Application No. 10/581,328
Reply To Office Action dated June 5, 2009
Response dated September 3, 2009

AMENDMENTS TO THE DRAWINGS

FIG. 3

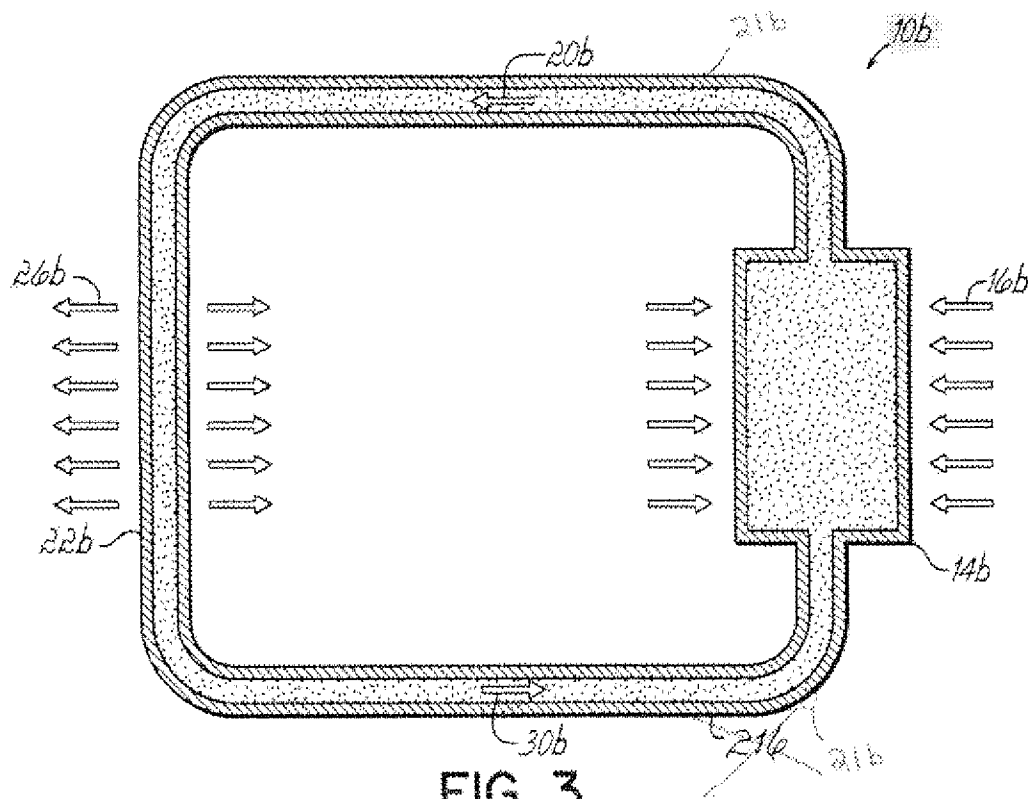
Attached are three drawing sheets showing the changes made to Figures 3, 5, 6, and 7,
and three replacement sheets for review and approval by the Examiner.

The drawings were objected to for failing to show every feature of the invention specified in the claims as well as for failing to show reference numeral 156 from the detailed description. Applicants have amended Figures 3, 5, 6, and 7 to correct typographical errors and to overcome these objections. More specifically, Figures 6 and 7 have been amended to show the regulation device (252, 352), the temperature sensor (250, 352) and the associated control lines (254, 256, 354, 356), thereby showing the embodiments of claims 27-31. A corresponding explanatory sentence for these features has also been added to paragraph [0051] of the specification: "Again the regulation device 252 is operatively coupled to the ventilator 240 via control line 254, to the temperature sensor 250, and to the regulator valves 278, 280, 286 via control lines 256." These amendments are fully supported by the original specification at paragraphs [0016], [0047], and [0056]. Applicants

FIG. 6

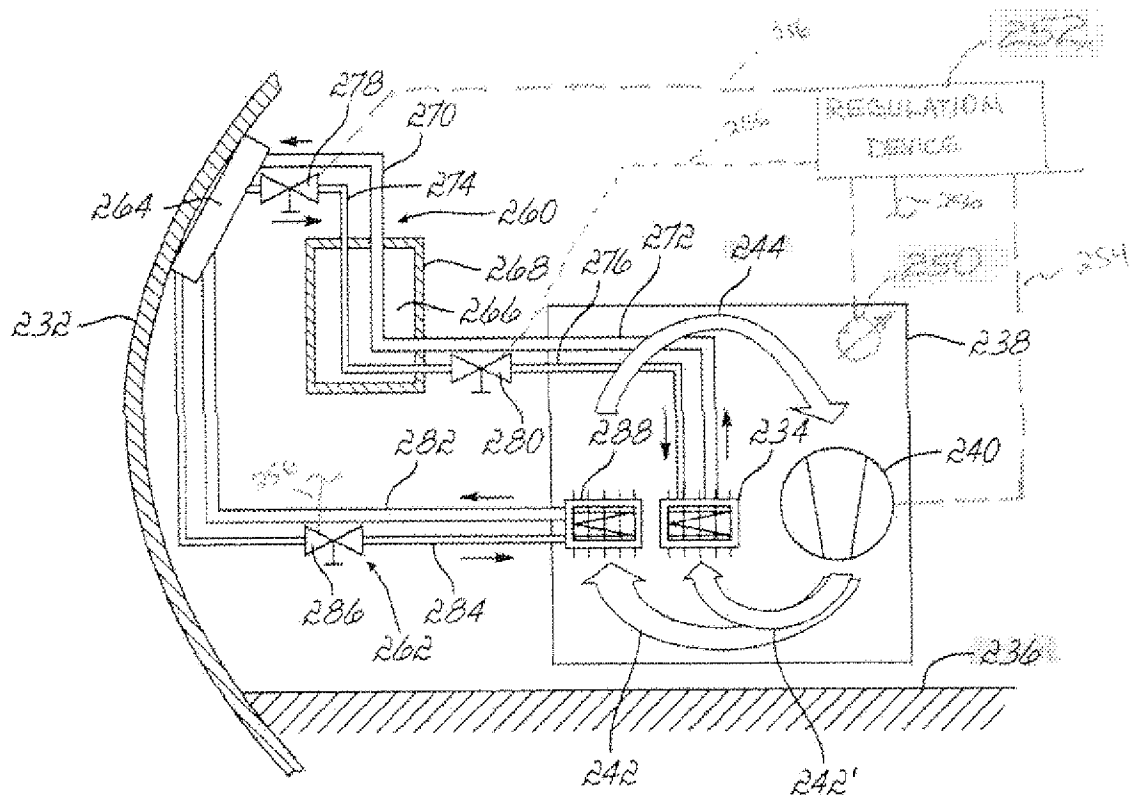
also observe that paragraph [0051] explains that the quantity of heat transferred by the system of Figure 6 can be changed by controlling the ventilator and/or the regulator valve, which is precisely the same control operations described for Figure 5. Thus, it is proper to amend Figures 6 and 7 to include the regulation device, the temperature sensor, and the control lines of Figure 5. Applicants respectfully request that the objections to the drawings now be withdrawn.
